SUBJECT: COMANCHE PEAK STEAM ELECTRIC STATION (CPSSES)
DOCKET NOS. 50-445 AND 50-446
SUPPLEMENTAL RESPONSE TO REQUEST FOR ADDITIONAL
INFORMATION ON LICENSE AMENDMENT REQUEST 94-022,
SPENT FUEL STORAGE CAPACITY INCREASE

RESPONSE TO NRC REQUEST FOR ADDITIONAL INFORMATION (RAI)
REGARDING SPENT FUEL POOL STORAGE INCREASE

Figure 11-1. Full DOF Nonlinear Finite Element Model (2-D View of 3-D Model)

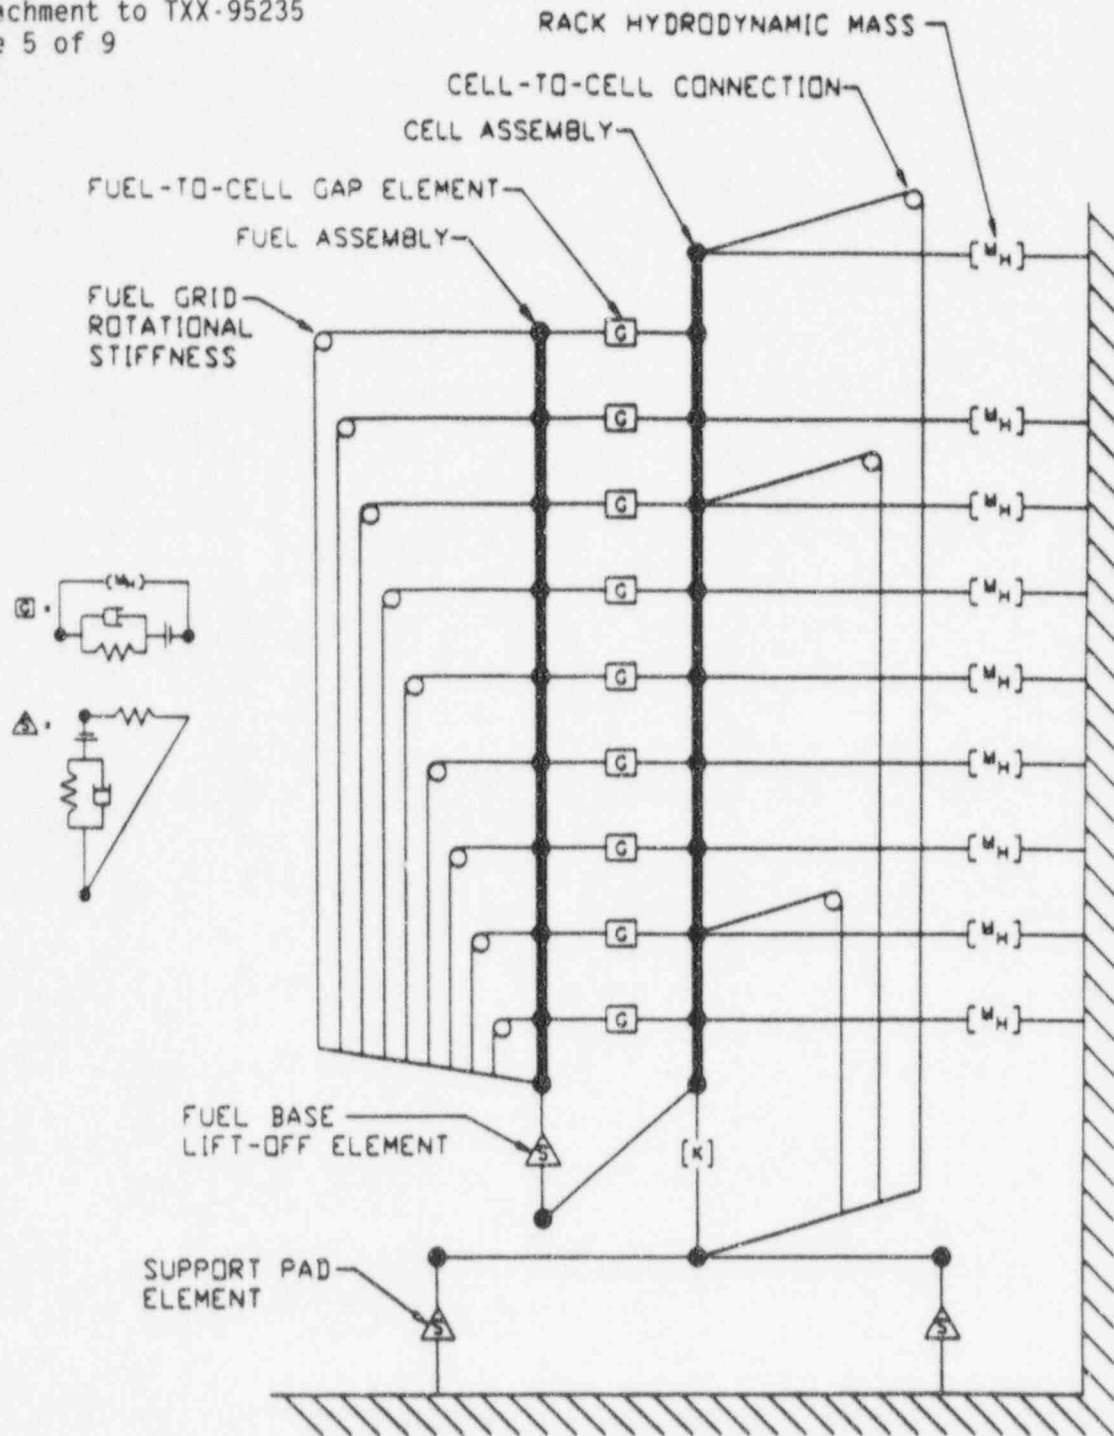
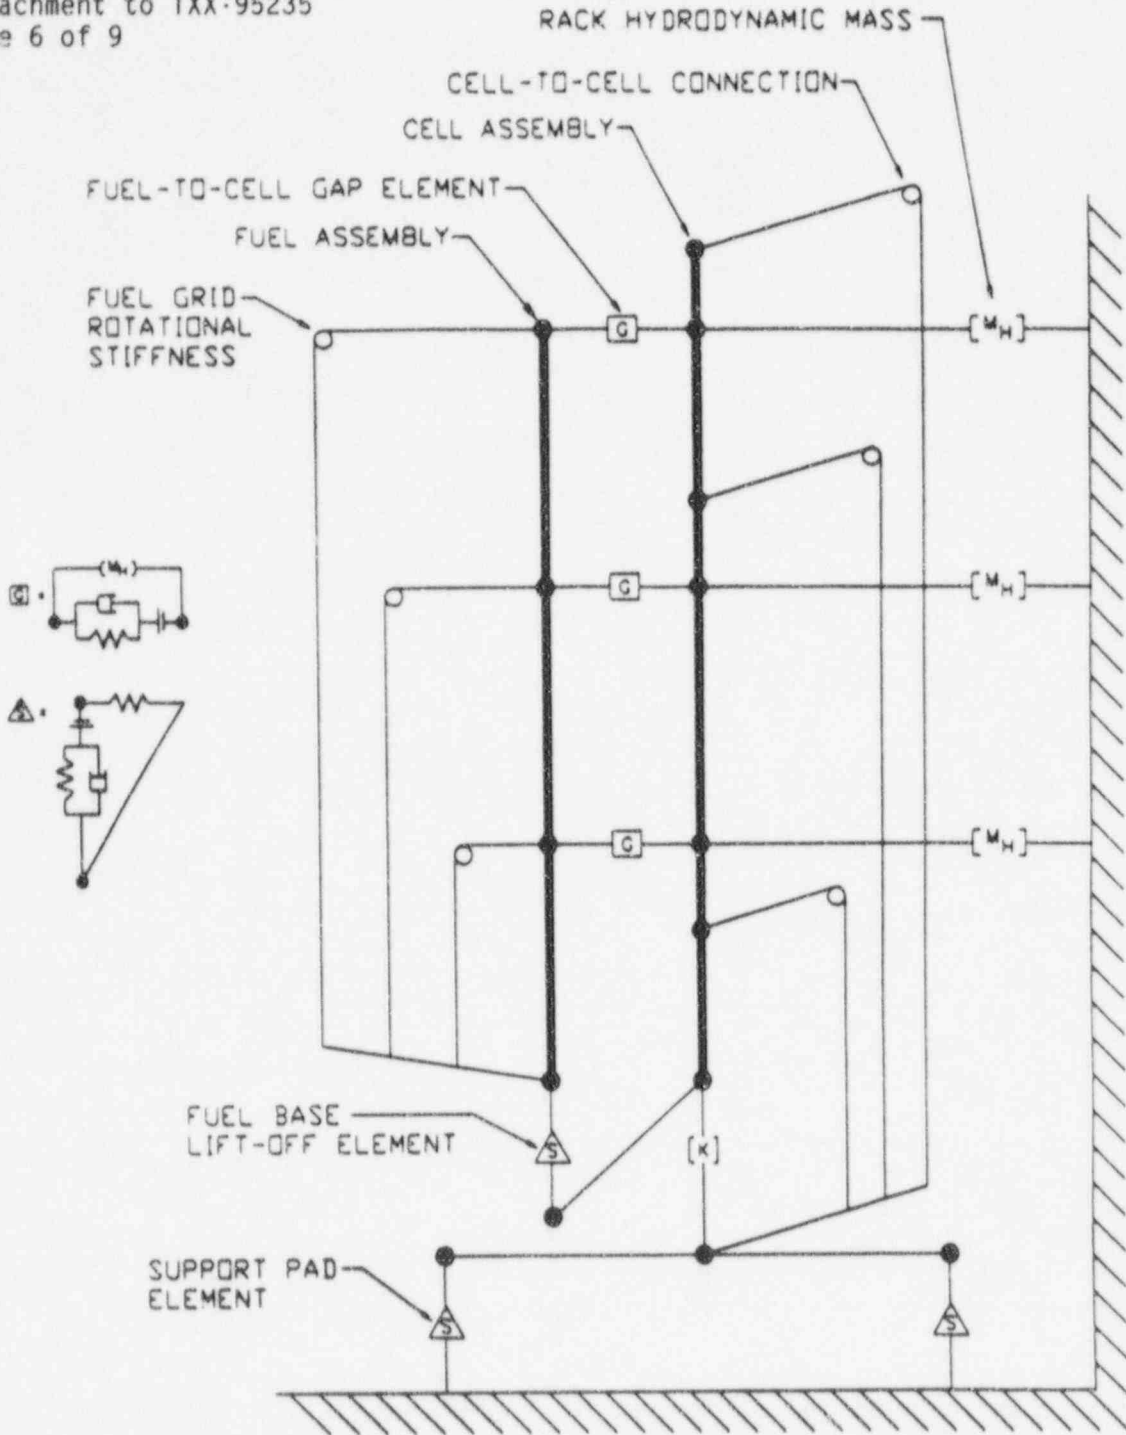
TU Electric indicated that the rack design is controlled by the results of the single rack analysis. Provide justification that the results of a single rack analysis are more conservative than the results of a whole pool multiple rack (WPMR) analysis, or provide comparison of results from a single rack and WPMR results.

In order to perform the WPMR analysis, a reduced element, i.e. reduced degree of freedom (DOF), finite element model for a single rack has been developed. Figure 11-1 shows the full DOF model (2-D view of the 3-D model) used in the single rack analysis, while Figure 11-2 provides the same 2-D view of the 3-D reduced DOF model used to represent an individual rack in the WPMR evaluation. Both models represent the rack in a similar manner, with the elements representing the rack base and support pads being the same in both models. The major difference between the full DOF and reduced DOF

models is a decrease in the number of elements used to represent the cell and fuel beams, the number of fuel to cell impact elements, and the number of elevations at which hydrodynamic fluid coupling mass matrix elements are used.

The reduced DOF model has been qualified by applying both SSE and OBE loadings using the same sets of acceleration time histories as in the full DOF single rack analysis. For both seismic loading conditions, evaluations were made for friction coefficients of 0.8 and 0.2. The results from the evaluation demonstrate that comparable displacements and loads are obtained for the reduced DOF model when compared to those of the full DOF single rack model. It is concluded, therefore, that the use of the reduced DOF model to represent an individual rack in the WPMR analysis is acceptable.
